SB-GA8-2009-53

Service Bulletin

Undercarriage Access Panel Retrofit

GA8-TC 320-08-130

Figure 1: Rivets to be removed from belly (only the inside rows of rivets of the double rows shown).

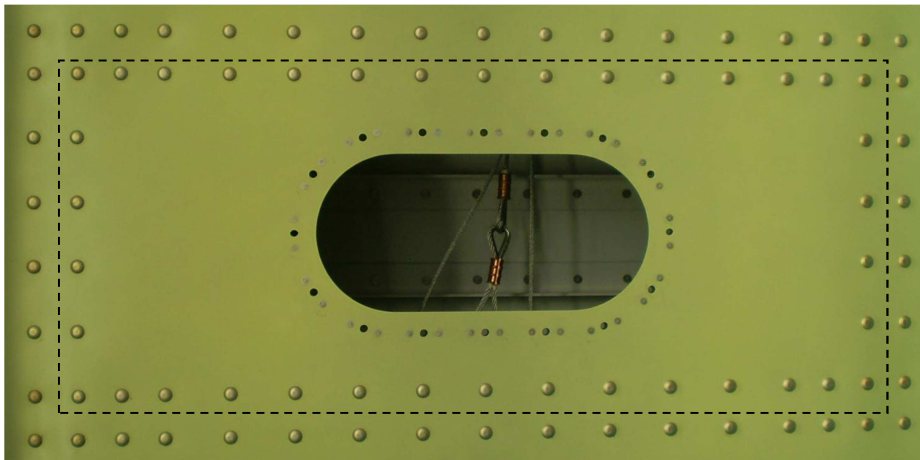
1. Jack aircraft as required.
2. Drill out and remove the domed head rivets within the dotted boundary shown in Figure 1 in the belly surrounding the existing undercarriage access panel.

Figure 2: Drill-off template detail.

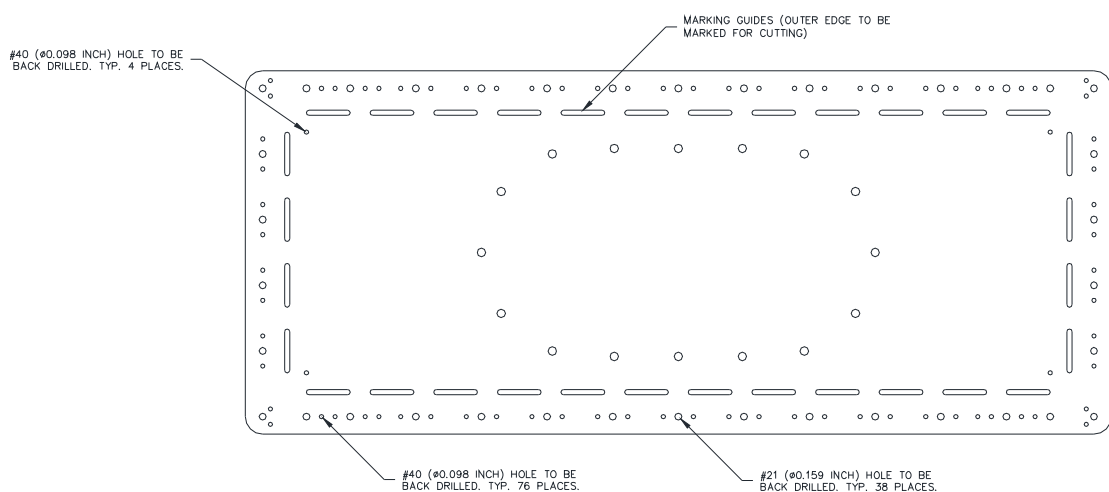
3. If the existing access panel is secured, unscrew and remove it.
4. Using the same screws for securing the existing access panel, secure drill-off template (P/N GA8-945321-021) to the belly in place of the existing access panel. Refer to Figure 2.

5. Drill the #21 (0.159 inch diameter) and #40 (0.098 inch diameter) anchor nut holes around the edge of the drill-off template, further securing the template as required by pinning it to the belly as holes are drilled.

6. Drill the four #40 (0.098 inch diameter) holes inside the corners of the marking guides of the drill-off template.
7. Mark the the new access hole using the marking guides in the drill-off template. The outside edges of the inch-long slots are the edges to be marked.

Figure 1: Hardware to be installed on belly skins

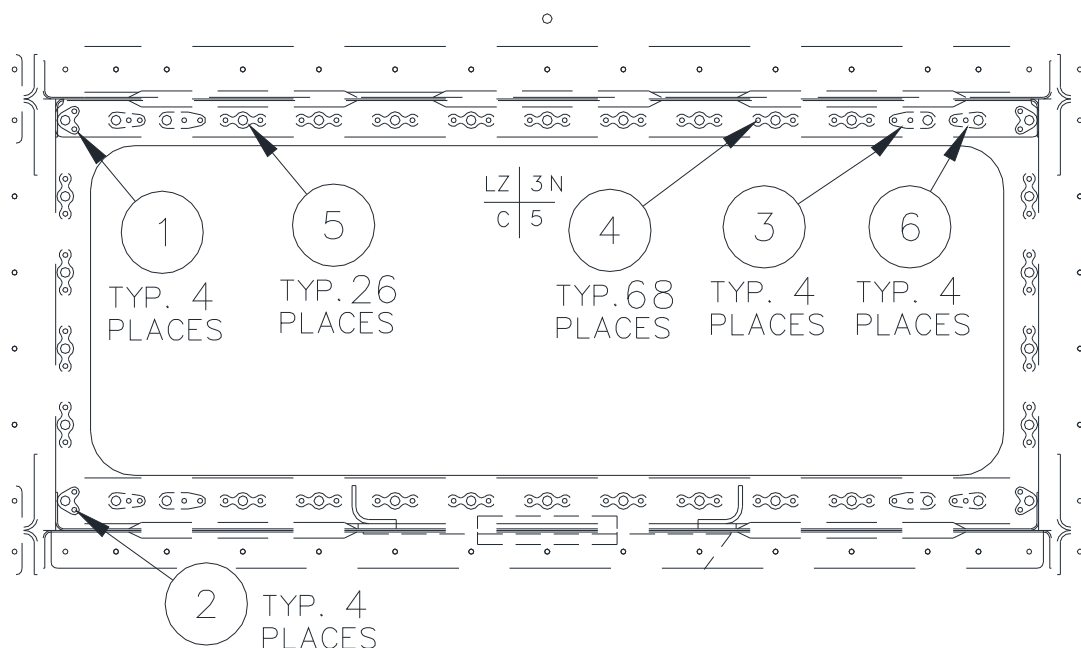
1. Jack aircraft as required.
2. Remove the existing mid cabin belly skin (P/N GA8-533021-25) and fwd cabin belly skin (P/N GA8-533021-13) surrounding the existing undercarriage access panel and replace it with GA8-533021-115 (mid cabin belly skin) and GA8-533021-113 (fwd cabin belly skin).

3. Install four MS21073L3 corner leg anchor nut in each corner using MS20426AD3-6 rivets.
4. Install four MS21051-L3 one leg anchor nuts inboard of each corner leg anchor nut using NAS1097AD3-5 rivets.
5. Install MS21047-L3 anchor nuts and MS21071-L3 one leg anchor nut in remaining locations using NAS1097AD3-5 rivets.
6. Install placard (P/N GA8-112011-401) onto the inside face of the new access panel (P/N GA8-533021-129).
7. Install the new access panel using AN525-10R8 screws.

Use of replacement skin P/N GA8-533021-113 and GA8-533021-115 will comply with the requirement to cut the larger hole in the existing skins.
